UNITED STATES PATENT AND TRADEMARK OFFICE

APPLICATION NO.	FILING DATE	FIRST NAMED INVENTOR	ATTORNEY DOCKET NO.	CONFIRMATION NO.
10/626,966	07/25/2003	William G. Dennis	MPD-001.01	3962

Office Action Summary	Application No. 10/626,966	Applicant(s) DENNIS, WILLIAM G.	
	Examiner TUAN V. NGUYEN	Art Unit 3731

DETAILED ACTION

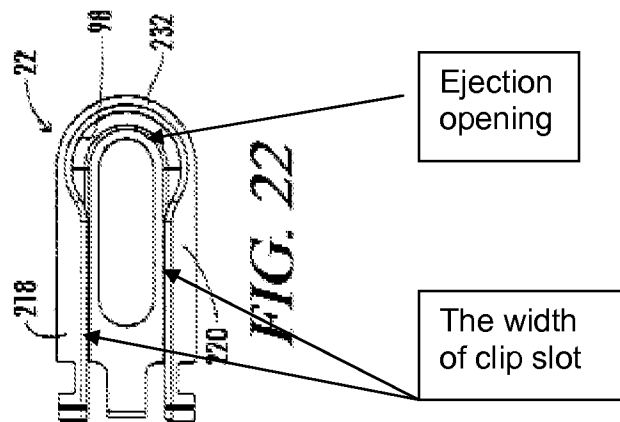
19. Referring to **claims 32 and 53**, Figure 22 (reproduced below) shows the jaw has a clip slot terminates in an ejection opening 98 adjacent the distal jaw end 232, the clip slot having a slot width and the ejection opening having an ejection opening width that is greater than the slot width.

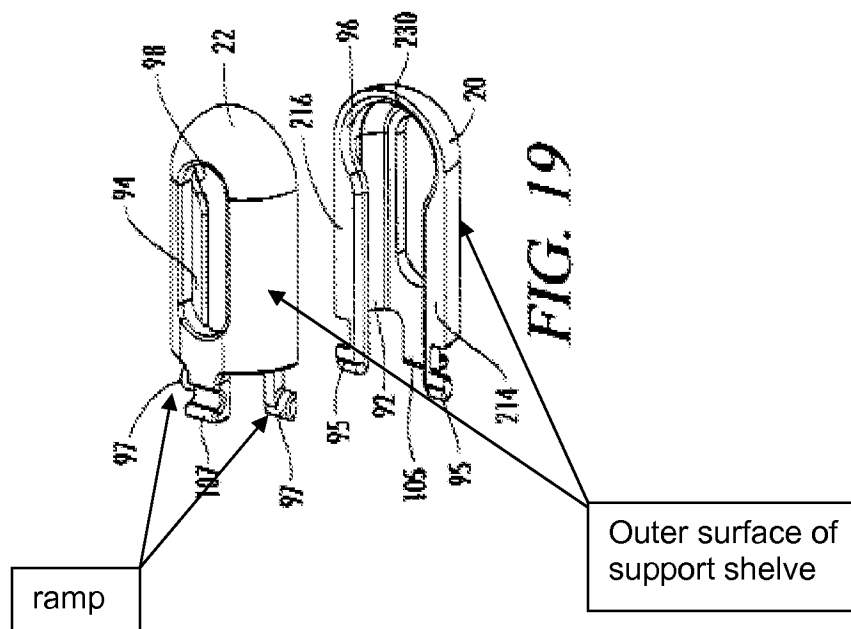
20. Referring to **claims 71 and 72**, Figs. 19 and 21 of Shipp's drawings show the elements 95 and 97 are not continuous with the outer surfaces of the respective support shelves has been fully considered but they are not persuasive. Figures 19 and 22 of Shipp's drawings show a pair of ramp, which includes elements 95 connected with first jaw side 214 and 216 (see Fig. 19), and elements 97 connected with second jaw side 218 and 220 (see Fig. 20), wherein the ramps having outer surfaces that aligned with the respective support rails 61 and 63 of the clip holder 58 (see Fig. 16) and are continuous with the outer surfaces of the respective support shelves (see Figs. 19 and 22 reproduced below this paragraph).
